SUBJECT: Minutes - Symbology Standards Management Committee (SSMC) Meeting, 15 April 1997

SYMBOLY CONFIGURATION MANAGEMENT  
CHANGE PROPOSAL FORM

**Figure A. 2.X.2.1.2.3.5  
(on white background)**

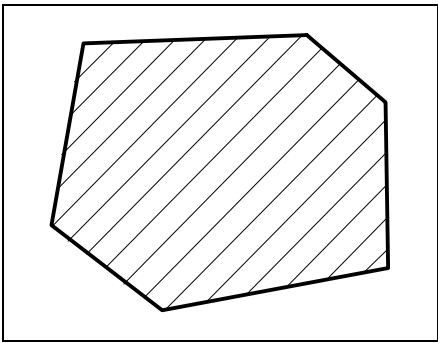
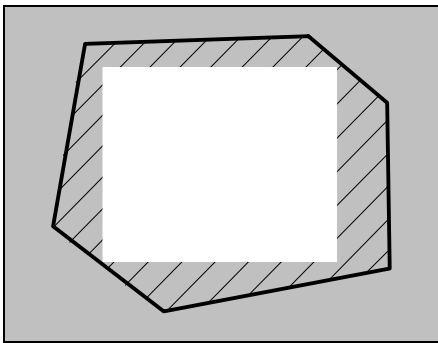
Review Tactical Graphics. Some tactical graphic symbols are constructed in segments that overlap. When the background color for the symbol is other than white, the symbol appears incorrect. For example, hierarchy number 2.X.2.1.3.5 (see Figure A) is made up of polylines with an overlapping rectangle containing information inside of it. Tactical graphics constructed with these polylines and rectangles normally appear on a white background (as they appear now in MIL-STD-2525A). When presented in this manner, only the information inside the rectangles appears on the symbol. The rectangle itself blends into the white background. However, when the symbol background color is not white, the symbol takes on an odd appearance (see Figure B) because the white rectangle shows up on the color background.

**FIGURE 3b. Placement of modifiers for points, areas, lines and boundaries.**

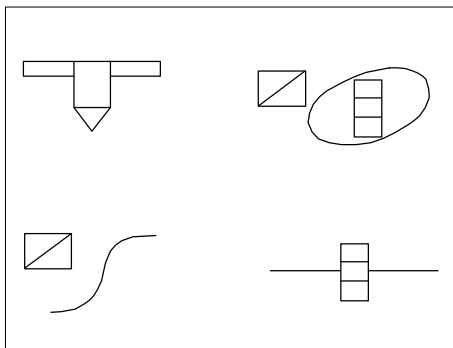
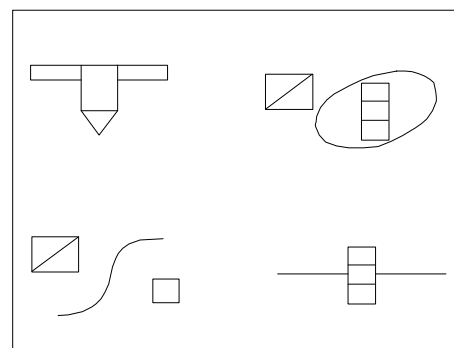
**FIGURE 3B. REVISE “LINES” PORTION OF FIGURE**

Figure 3b, page 25 (see A below). Lower left corner of figure. Change “T” and “T(1)” to “A”. The “A”, (meaning symbol indicator) is more representative to the figure (see B below). In addition, add “H” to the same portion of the figure to indicate additional information can be added.

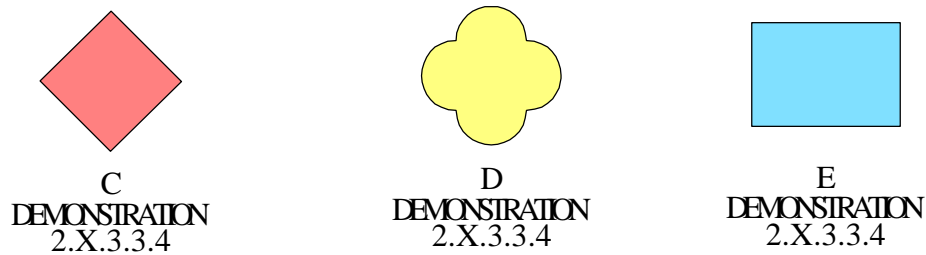
Recommend creation of hierarchy 1.X.7, titled “EVENT”, in appendix D. At the present time, appendix D (warfighting graphics) consists of units, installations, and equipment, but has no category encompassing events. In reality, events come in all variations; unknown, friendly, neutral, and hostile. They cover a broad spectrum of situations from drive by shootings to nuclear incidents and range from conditions of absolute war to operations other than war. It is important that this document establish a category for “events” which occur in situations of absolute war and other than war related scenarios.

Right now, MIL-STD-2525A contains “Military Operations Other Than War” (MOOTW) symbols in the tactical graphics section of the document and these account for a number of items that can be considered events. This proposed new track will encompass occurrences that pinpoint a time or place and is based on analysis of point graphics found in the tactical graphic portion of MIL-STD-2525A. In reviewing the MOOTW portion of tactical graphics (2.X.3s), one can see the use of frames with symbols gives the distinctive feel of appendix D symbols being misplaced in appendix E tactical graphics. For example, 2.X.3.1.4, BOMB/BOMBING (see A and B below) is presented both as a hostile and an unknown; 2.X.3.3.4, DEMONSTRATION (see C, D, and E below) is presented as hostile, unknown, and friendly. It can be argued that these and other symbols in the tactical graphics portion of the standard can be

framed in all four categories; unknown, neutral friend and hostile.
